Montana State University
Brick Breeden Fieldhouse Locker Room 116 Renovation
Bozeman, Montana 59717

ADDENDUM #1
This addendum consists of: 1 pages

Subject: MSU Brick Breeden Fieldhouse Lock Room 116 Renovation
Job Number: 22057.01 PPA #21-0028

A-AI10

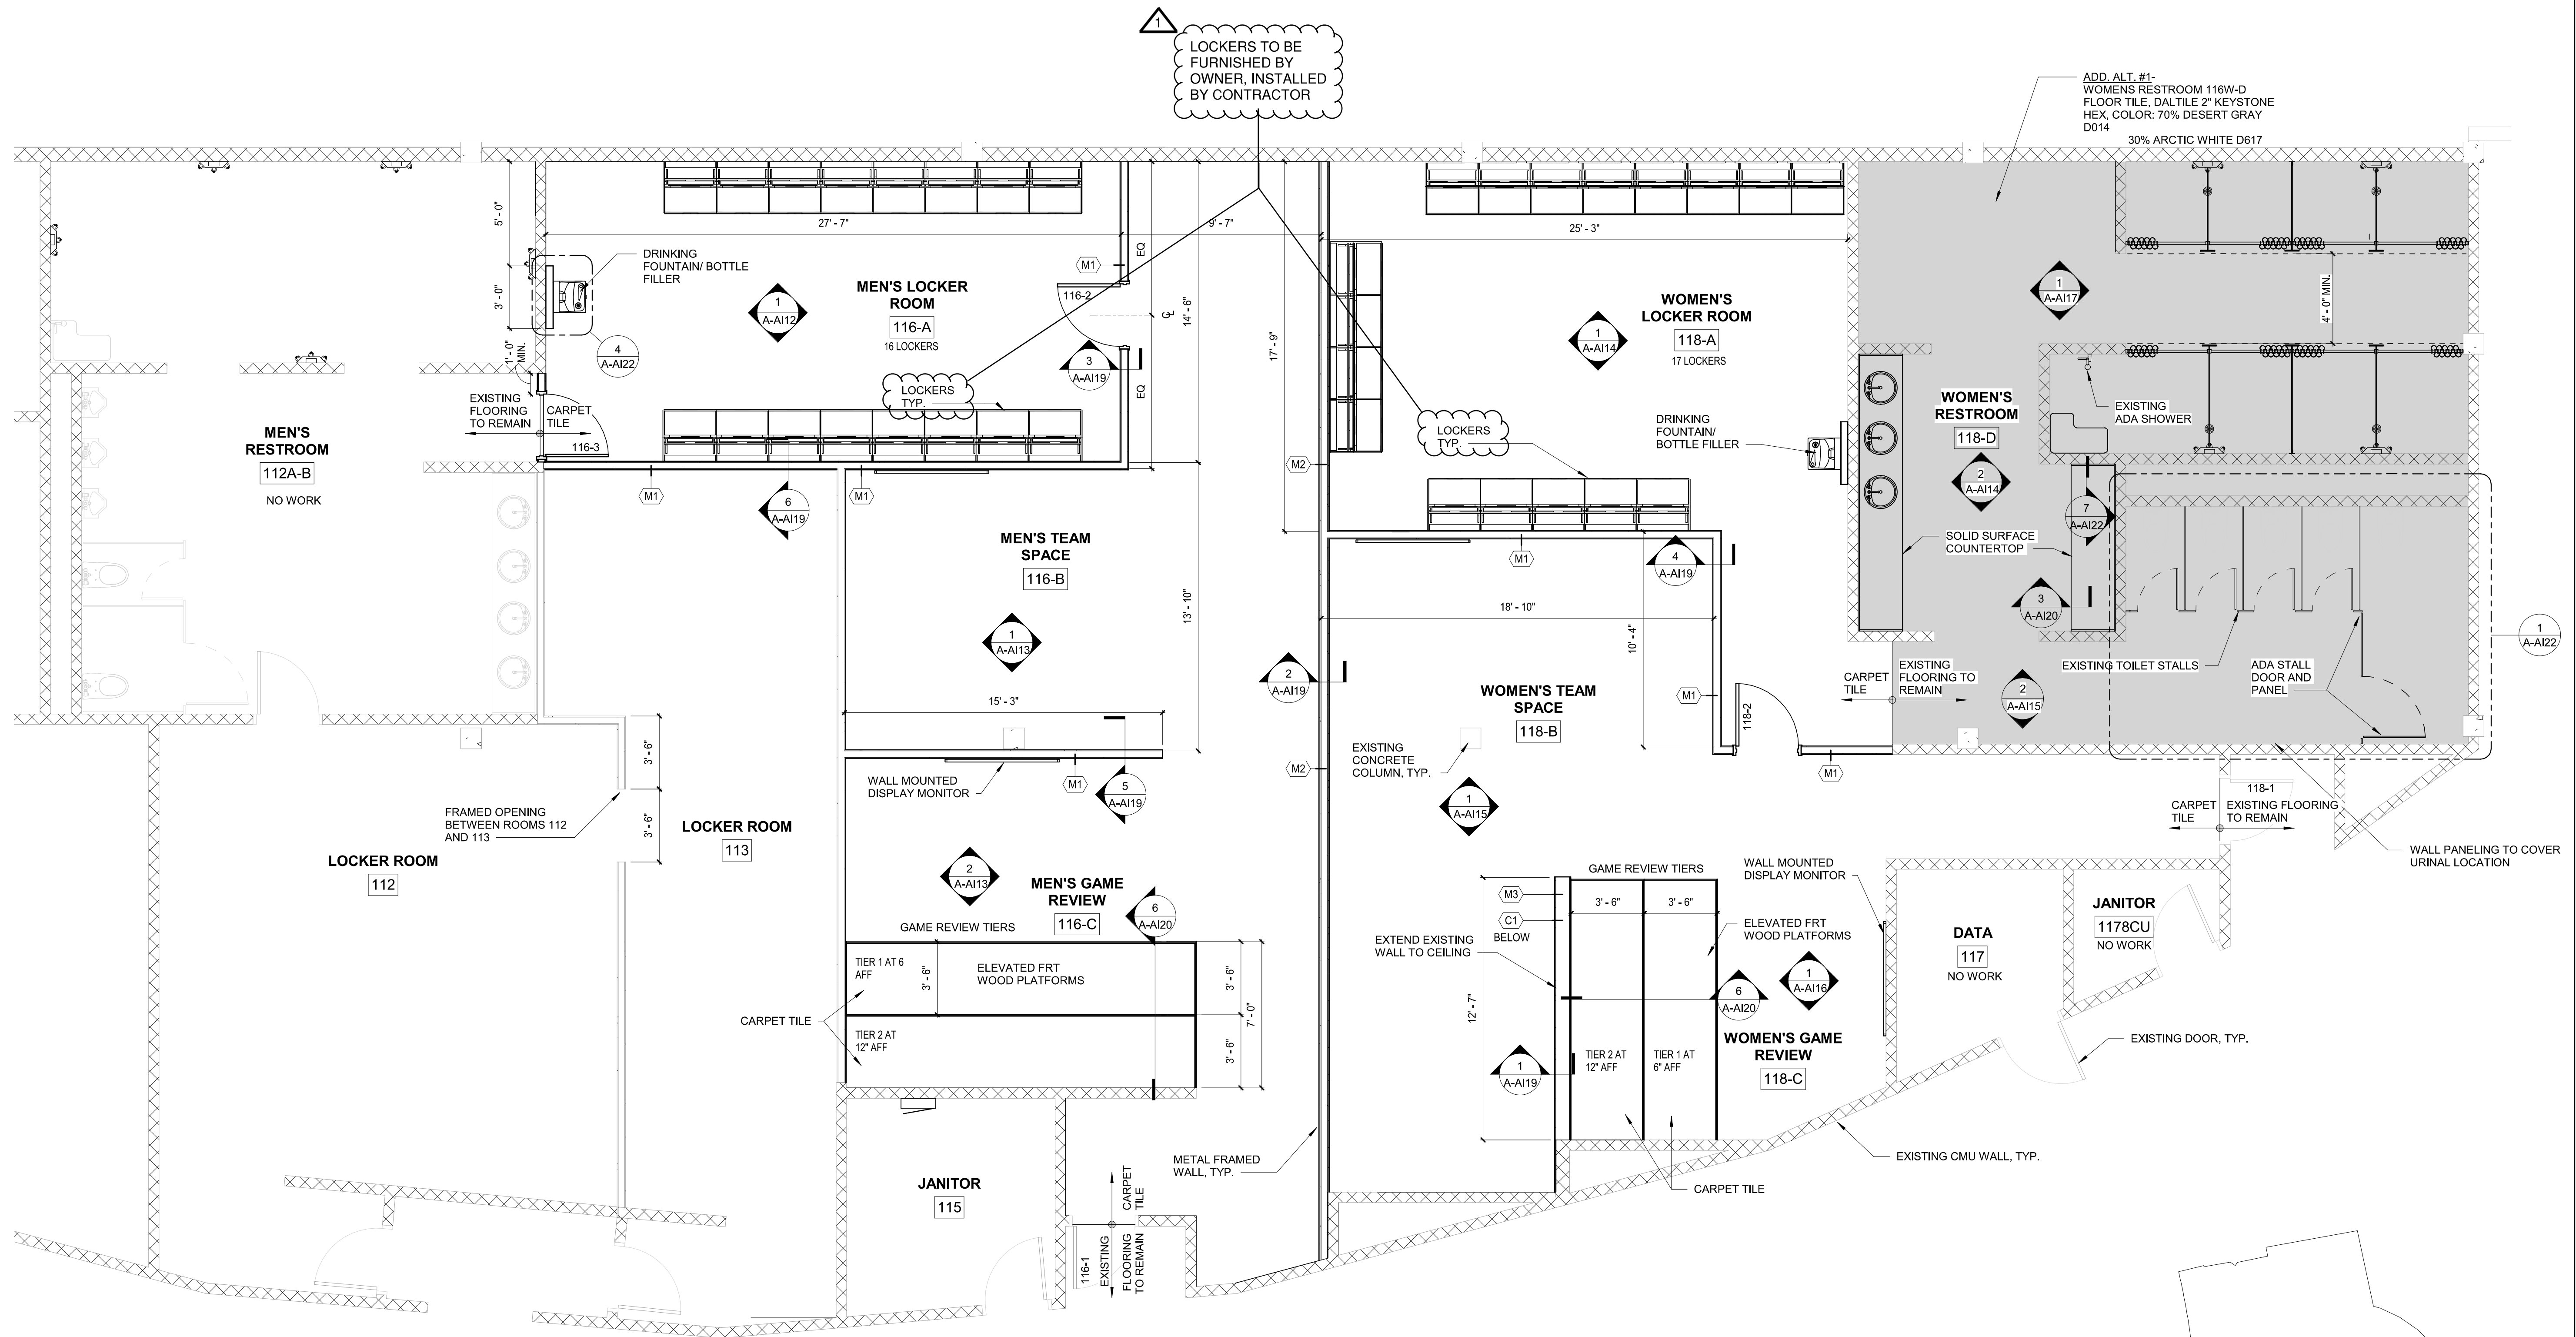
LOCKERS TO BE FURNISHED BY OWNER, INSTALLED BY CONTRACTOR

**SHEET
 A-A12**

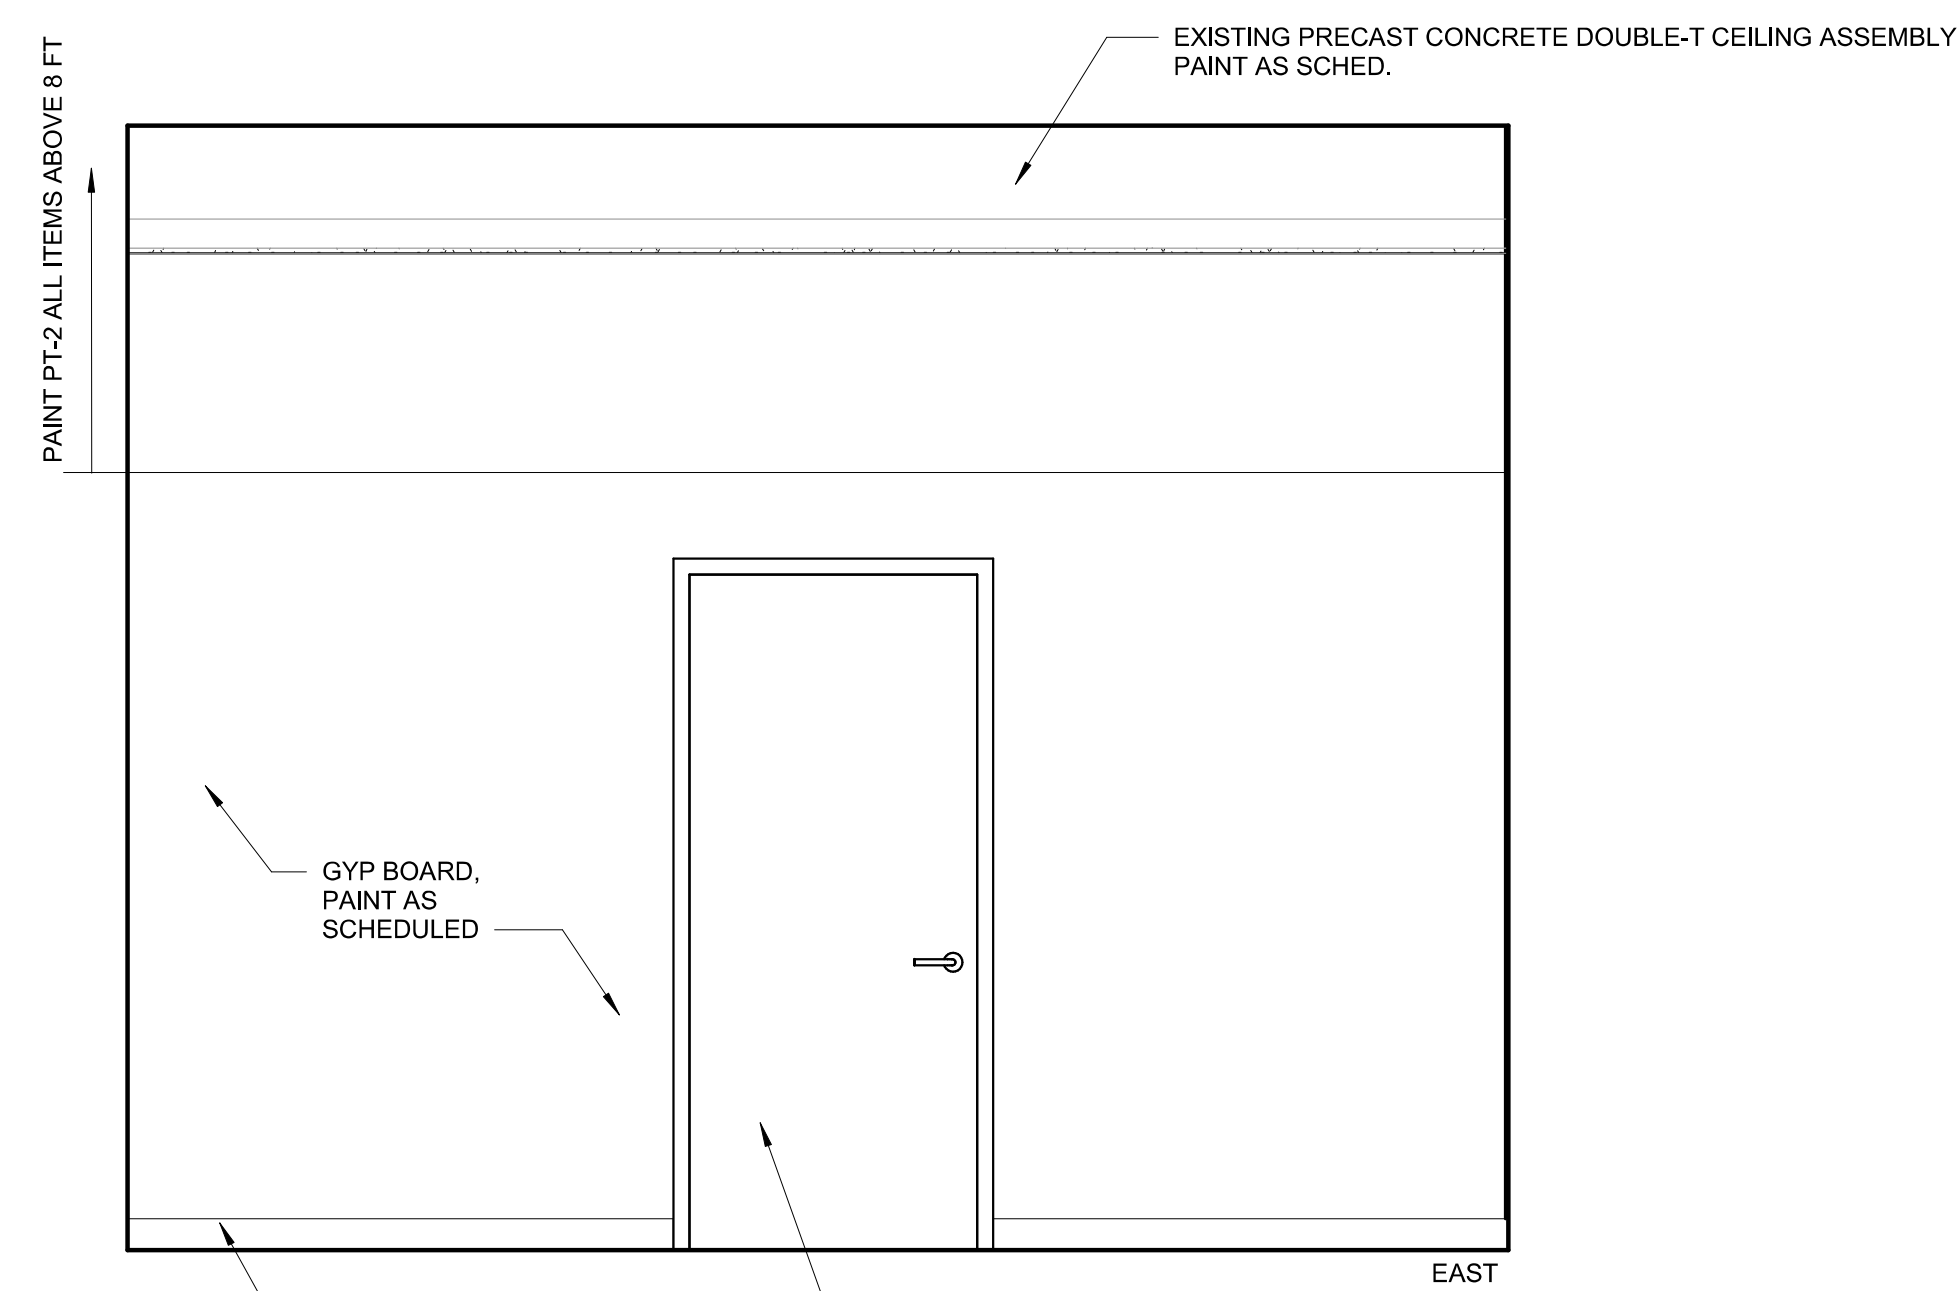
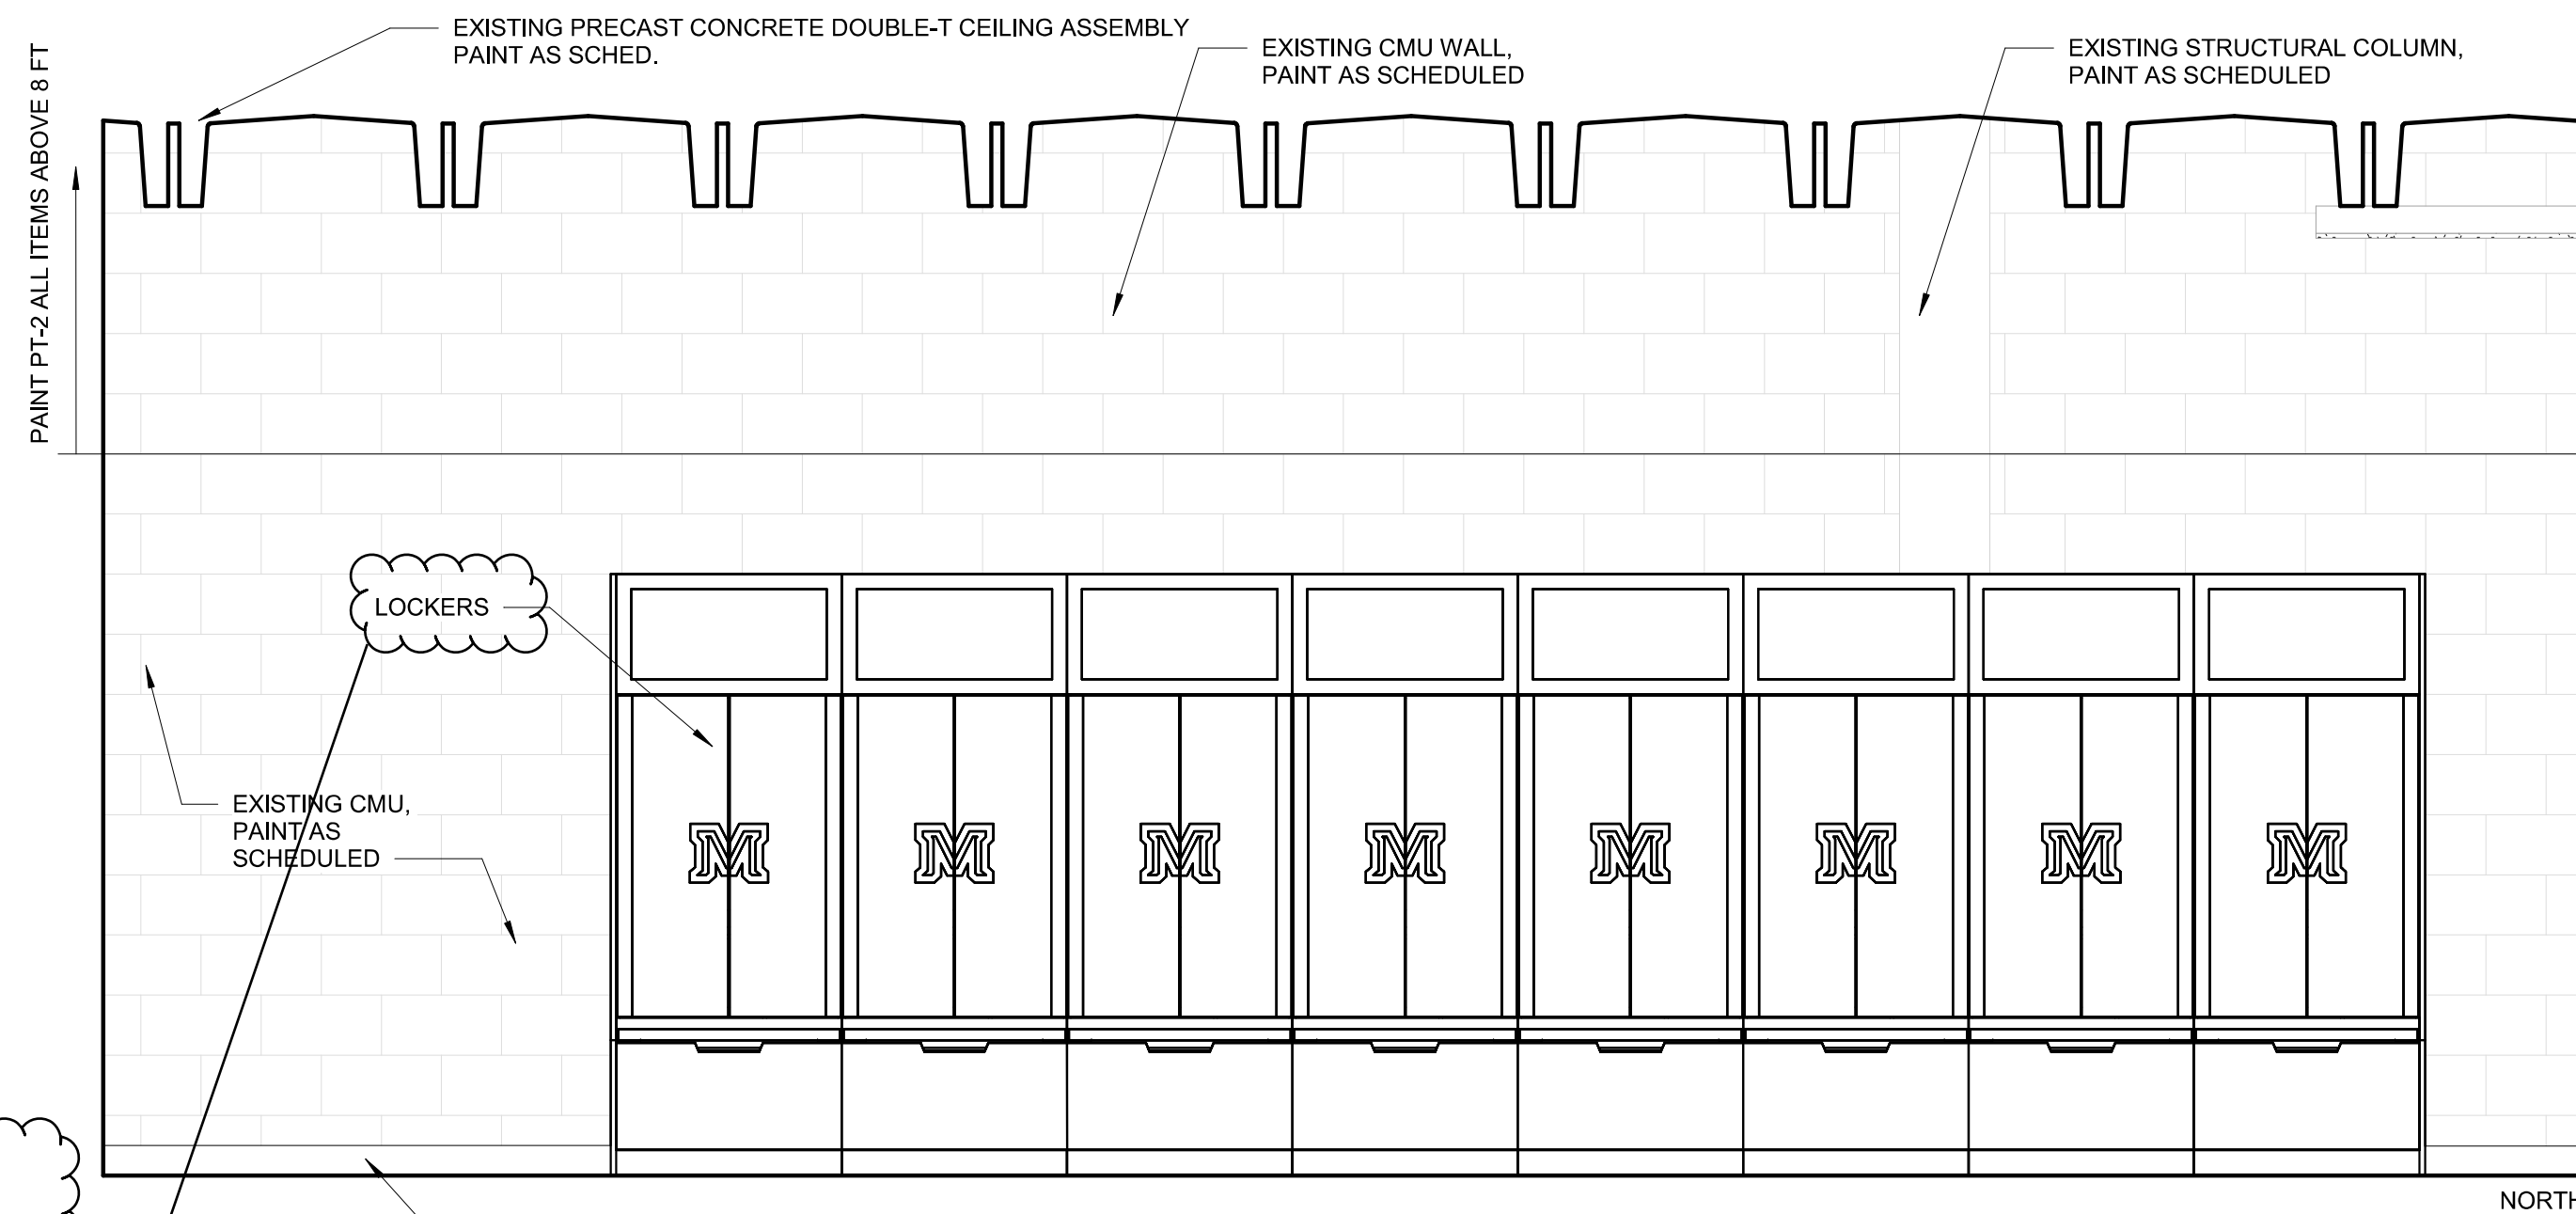
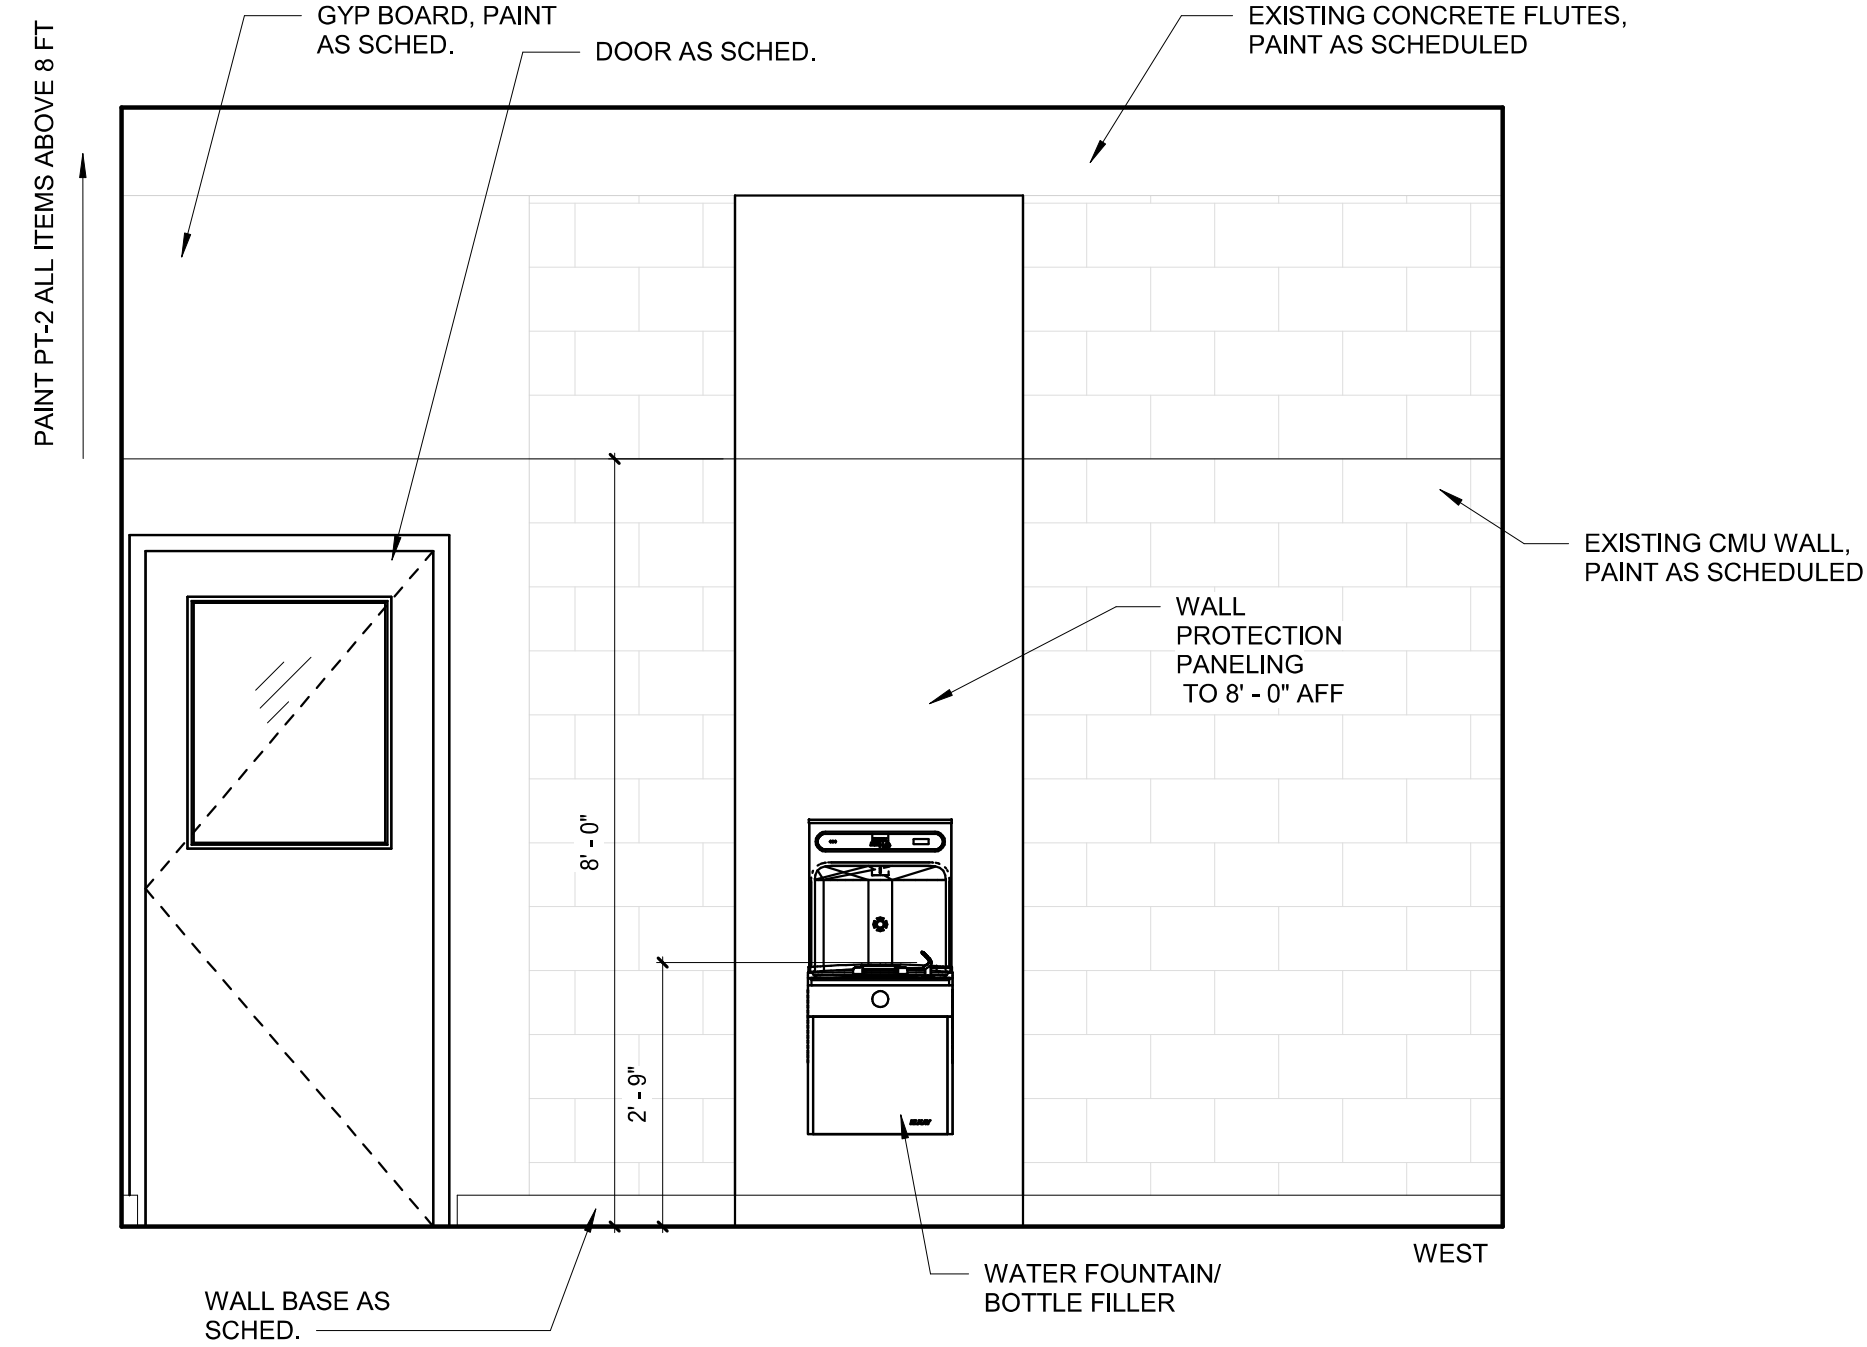
LOCKERS TO BE FURNISHED BY OWNER, INSTALLED BY CONTRACTOR
